NextEra Energy Transmission West and Pacific Gas and Electric Company Estrella Substation and Paso Robles Reinforcement Project Proponent's Environmental Assessment (A.17-01-023)

Updated Response to Data Request No. 1 as of January 14, 2019

Exhibit 1-1: Updated Figure 5, Updated LoadSEER Forecast, Paso Robles DPA

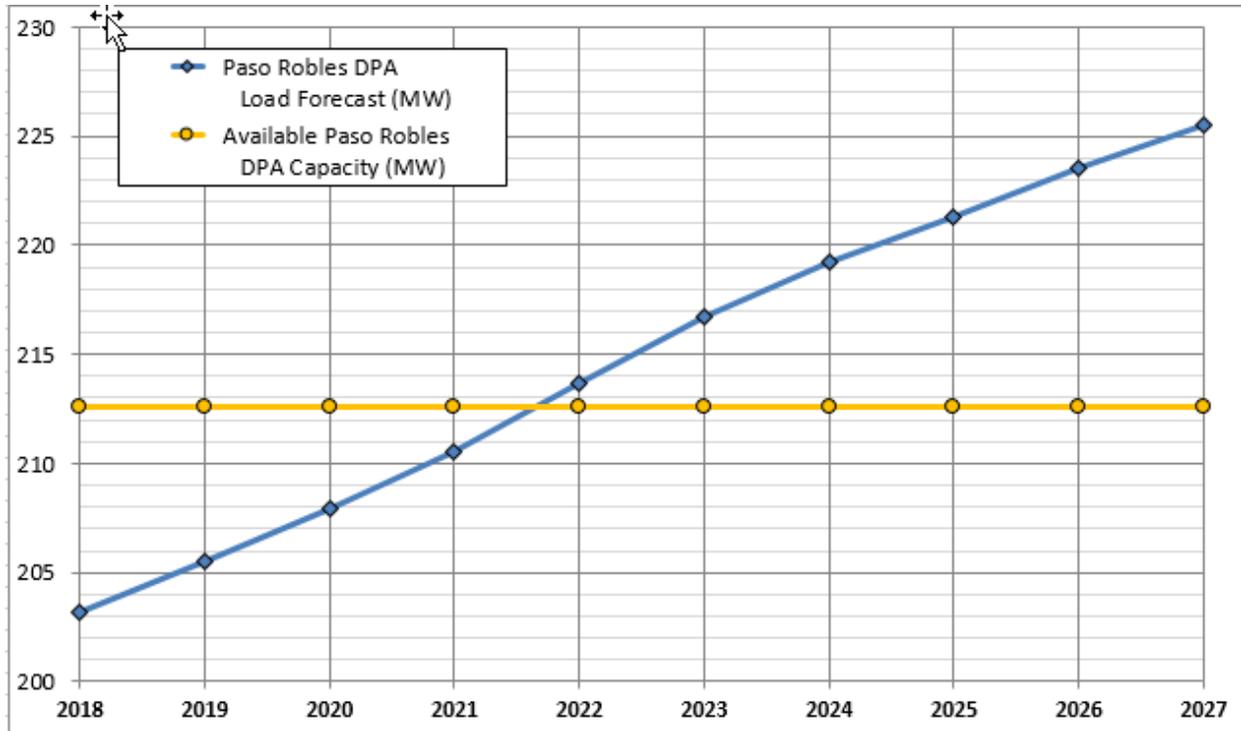
In the January 2018 version of Appendix G, the LoadSEER forecast for 2017 for the Paso Robles DPA was 207.6 MW (See Figure 5). In the June 2018 update to Appendix G, the actual load for the Paso Robles DPA was updated to be 195.06 (see Table 2), a difference of 12.34 MW. However, in the June 2018 update to Appendix G, the Load SEER forecast (see Figure 5) has not been adjusted to reflect the lower value for 2017, but instead was unchanged and left at 207.6 MW. This results in a rather large jump of 6.42% between 2017 actuals and 2018 LoadSEER forecast while the annual load growth for the remainder of the forecast (2018 to 2026) averages just 0.55%. Please explain the load increase assumed between 2017 and 2018 and why it is significantly larger than the rest of the forecast. Please provide an updated Figure 5, including both the chart and forecast table shown in Figure 5.

In Exhibit 1-1 below, we have provided an updated Figure 5, including the chart and forecast table, based on the LoadSEER forecast prepared in 2018 and provided to CAISO. This updated LoadSEER forecast incorporates the historical peak loads for 2005 to 2017 in the Paso Robles DPA. The updated Figure 5 is the forecasted peak loads for 2018 through 2027. This new forecast shows that the forecasted peak load could exceed the 212.55 MW of available capacity in the DPA by 2022, which is earlier than 2024 as indicated in the previous LoadSEER forecast.

Exhibit 1-2a: Paso Robles TPP 2018-2019 Load Model vs. LoadSEER (Appendix G Table 4)

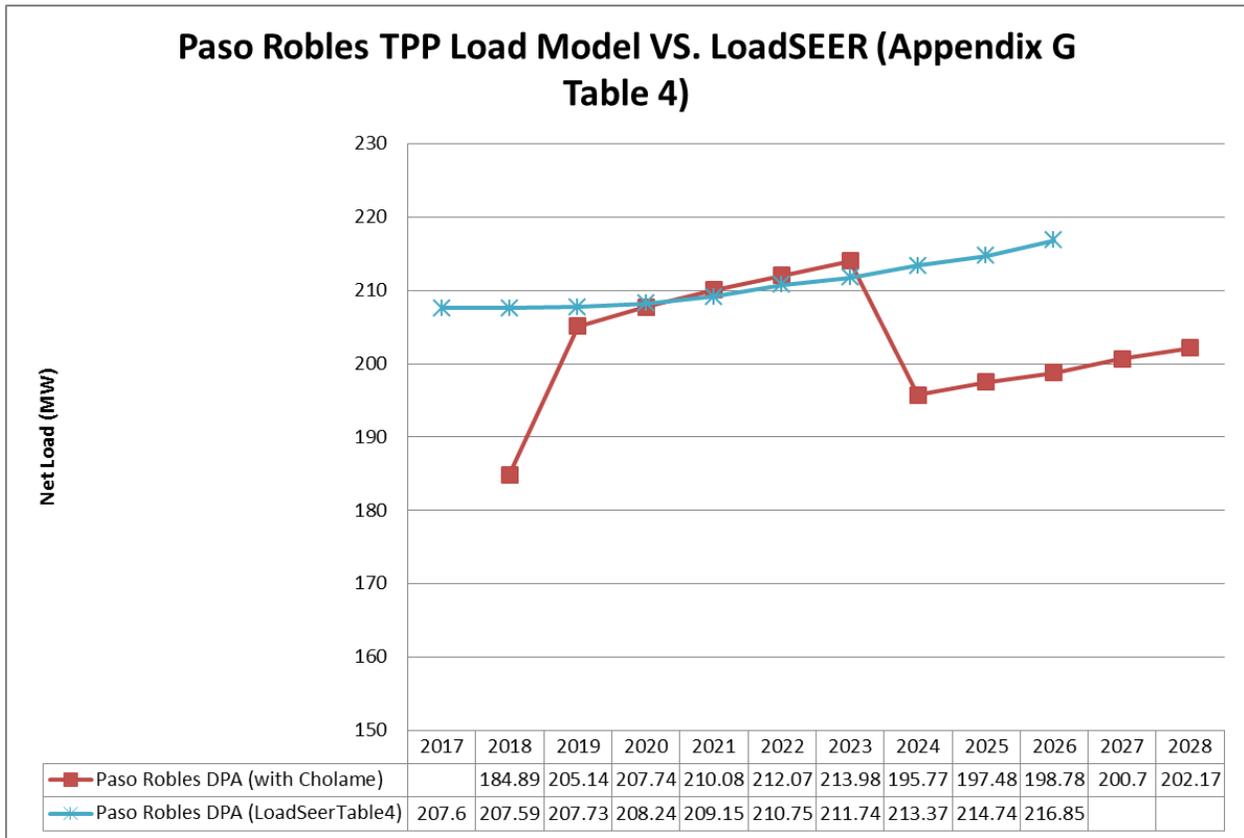
In the CAISO 2018-2019 Transmission Planning Process the CAISO has the 2028 Paso Robles DPA load modeled at 202.17 MW (Cholame = 7.2 MW, San Miguel = 10.95 MW, Estrella = 24.8 MW, Templeton = 68.84 MW, Atascadero = 27.58 MW, and Paso Robles = 62.8 MW). For 2020 and 2023, in the CAISO 2018-2019 TPP cases, the Paso Robles load is 207.74 MW and 213.98 MW respectively. The loadSEER forecast for 2020 (208.24 MW) and 2023 (211.74 MW) are relatively consistent with CAISO assumptions for these years.

However, there seems to be a significant disconnect for years beyond 2023. The loadSEER forecast continues to increase at a rate of roughly 0.7% while the CAISO TPP is showing a decrease of 0.33%. The CAISO attributes the reduction to behind the meter solar and energy efficiency. Please provide an explanation and justification for the loadSEER forecast increasing growth rate with respect to the CAISO TPP decreasing forecast for years beyond 2023.

The load forecasts mentioned in Request #1-2, e.g., the CAISO 2018-2019 TPP and LoadSEER forecast for 2017 to 2026, are plotted in Exhibit 1-2a. For 2020 and 2023, as identified in the request, the CAISO’s 2018-2019 TPP load forecast numbers are similar to the LoadSEER forecast. Then the forecasted values for the years beyond 2023 are different.
